20 October 2022

The Chief Executive Officer
Northern Beaches Council
Attention: Mr Kye Miles

STATEMENT OF ENVIRONMENTAL EFFECTS - ADDENDUM
27 Gulliver Street, Brookvale
DA2022/1176

Excerpt from the landscape plan of the proposed eastern interface

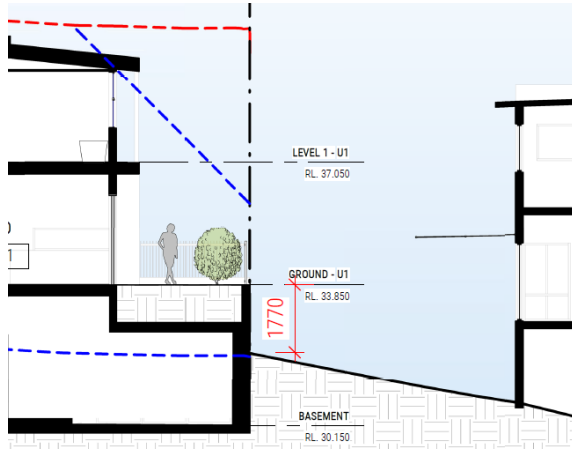
3. Consider different apartment types and orientation to resolve conflicts with neighbouring properties;
4. Reduce the scale of the building and the private open spaces and fences in relation to the eastern neighbour;
5. Create more built form articulation along the eastern elevation;
6. Create more consistent roof forms, with possibly greater articulation.

- The natural fall of the land is to the north-east, in the direction of the eastern adjoining property that is adjacent to proposed dwelling 1. The proposal does not represent an inappropriate level difference but rather an appropriate interface in terms of privacy landscaping, and visual presentation with no objection from this property.
